# DONAL CAREY & COMPANY ARCHITECTURAL DESIGNERS

15<sup>th</sup> October 2001

**Ref: Alterations to No. 34/36 BURY WALK, SW3**

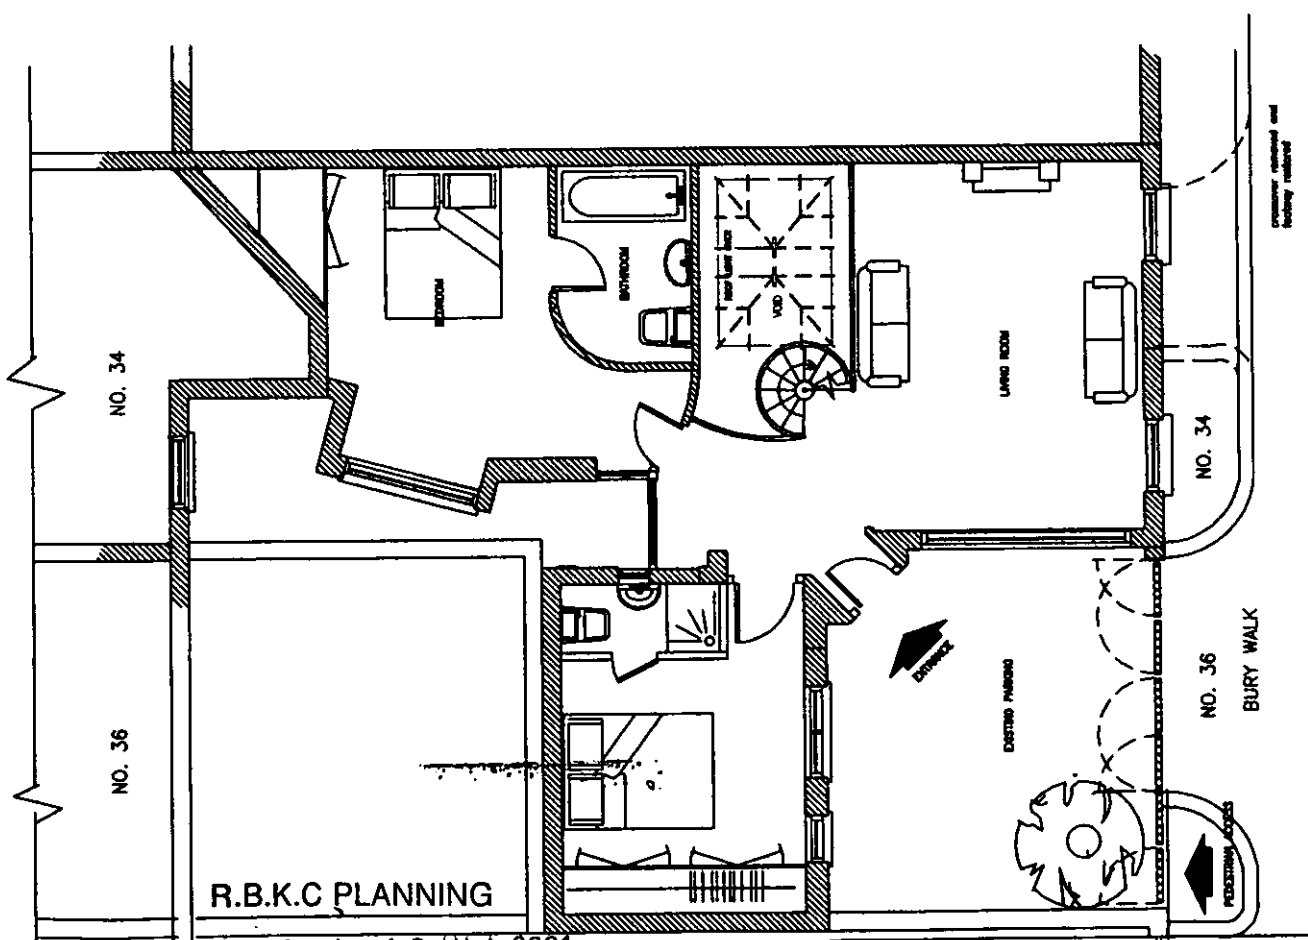
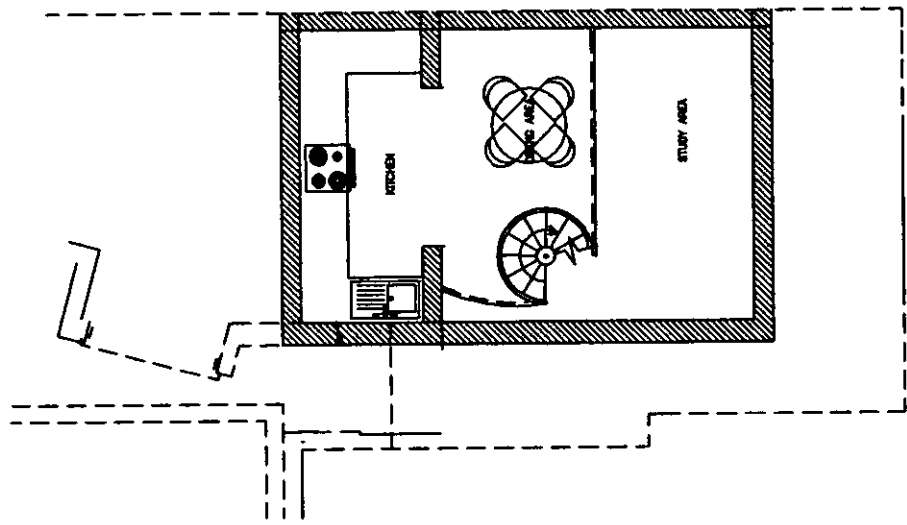
I enclose a sketch of a proposal to create a small basement area within the curtilage of the existing building. It is to provide a kitchen/ dining room area. There is no alteration to the outer envelope of the building and there is no risk of damage to trees.

Advised on Don Carey's answerphone that formation of a basement would be likely to be acceptable but would need planning permission since it would increase the cubic content of the original dwelling by more than 10%.  
John Shearman. (7/12/01).
